Technical Service Bulletin

40 Front stabilizer bar is noisy

40 13 31 2010330/4 July 19, 2013. Supersedes Technical Service Bulletin Group 40 number 08-11 dated November 14, 2008 for reasons listed below.

Model(s)	Year	VIN Range	Vehicle-Specific Equipment
TT	2004	000001 - 025177	Not Applicable

Figure 1. Front stabilizer bar (1), rubber mount (2) and coupling links (3).

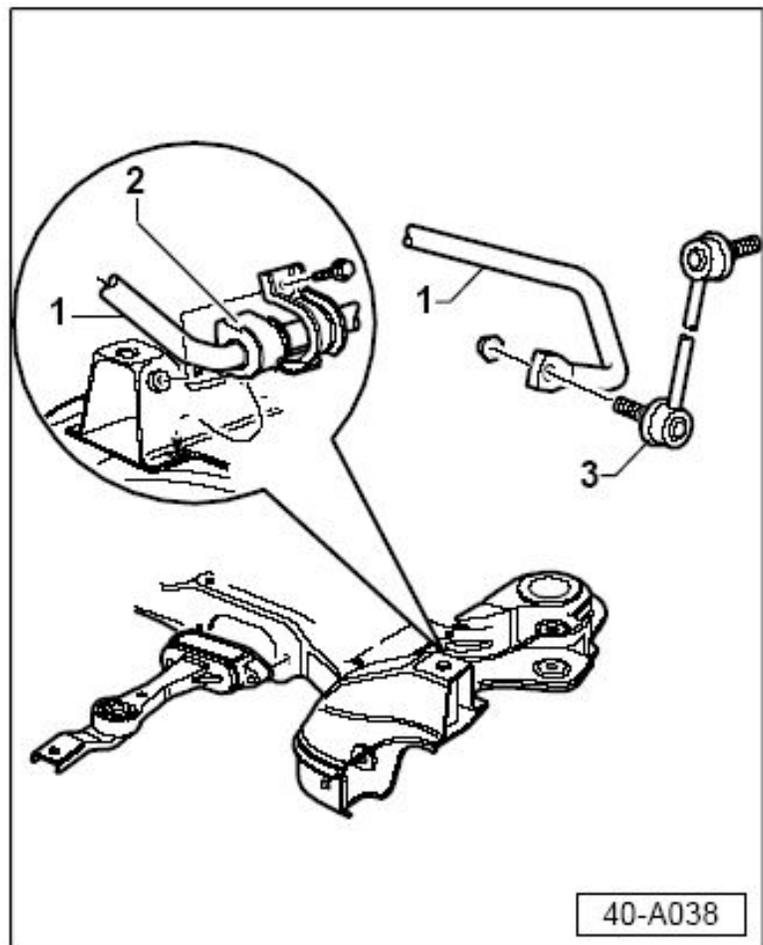
1. Test drive the vehicle to verify customer concern. The noise may only be present when vehicle is either warm or cold.
2. Visually inspect underbody for damage.
3. Inspect the front stabilizer bar (Figure 1, 1) at rubber mount (Figure 1, 2) for any signs of damage, such as the bushing sleeve separated from stabilizer bar.

1. Disconnect left and right side coupling links (Figure 1, 3) from front stabilizer bar and move stabilizer bar (Figure 1, 1) up and down several times. Observe rubber mount (Figure 1, 2) for any signs of damage, such as the bushing separated from stabilizer bar.
2. If bushing has separated from stabilizer bar, replace stabilizer bar. (Only new version parts are available as replacement parts).
